MID SUSSEX DISTRICT COUNCIL

DM/21/3870

BURGESS HILL NORTHERN ARC, LAND NORTH AND NORTH WEST OF BURGESS HILL, BETWEEN BEDELANDS NATURE RESERVE IN THE EAST AND, GODDARD'S GREEN WASTE WATER TREATMENT WORKS IN THE WEST

RESERVED MATTERS APPLICATION PURSUANT TO OUTLINE APPLICATION DM/18/5114, TO CONSIDER ACCESS, APPEARANCE, LANDSCAPING, LAYOUT AND SCALE FOR THE ERECTION OF 247 DWELLINGS, ALTERATIONS TO LOWLANDS FARM AND ITS CONVERSION TO FORM 2 DWELLINGS, ASSOCIATED CAR PARKING, OPEN SPACE AND INFRASTRUCTURE, INCLUDING AN EXTENSION TO BEDELANDS NATURE RESERVE AND PROVISION OF THE GREEN CIRCLE (PEDESTRIAN/CYCLE/EQUESTRIAN ROUTE) AND PEDESTRIAN/CYCLE ROUTE FOR SUB-PHASES P1.3, P1.5, P1.6, OS1.5, OS1.6 AND PART OF OS1.1A, OS1.1B AND OS1.2N TO THE EAST OF ISAACS LANE AND LOWLANDS FARM AT THE NORTHERN ARC DEVELOPMENT ON LAND NORTH AND NORTH-WEST OF BURGESS HILL (AMENDED DESCRIPTION FOLLOWING THE RECEIPT OF AMENDMENTS)

Fig 1: extract from Aecom Phase 1 habitat survey with main impacted section highlighted

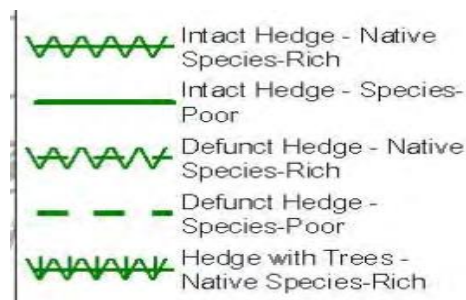
With regard to habitat impacts, there is a discrepancy between baseline hedgerow surveys undertaken by Aecom for the outline application and the results presented by Greengage for this reserved matters application, with the former indicating that hedgerows that will be lost (or subsumed within built development) are species poor (see Fig 1 below) and the latter suggesting that they are species rich . This discrepancy needs explanation and the status of any hedgerows to be lost should be confirmed with survey data conforming to standard hedgerow sampling methodology (as set out in the Hedgerows Regulations 1997). Species rich hedgerows are indicative of older hedgerows which pre-date the typically species-poor hedgerows planted under the enclosure acts and may be deemed irreplaceable due to landscape heritage value and biodiversity value developed over centuries. Policy 180 of the NPPF states that:
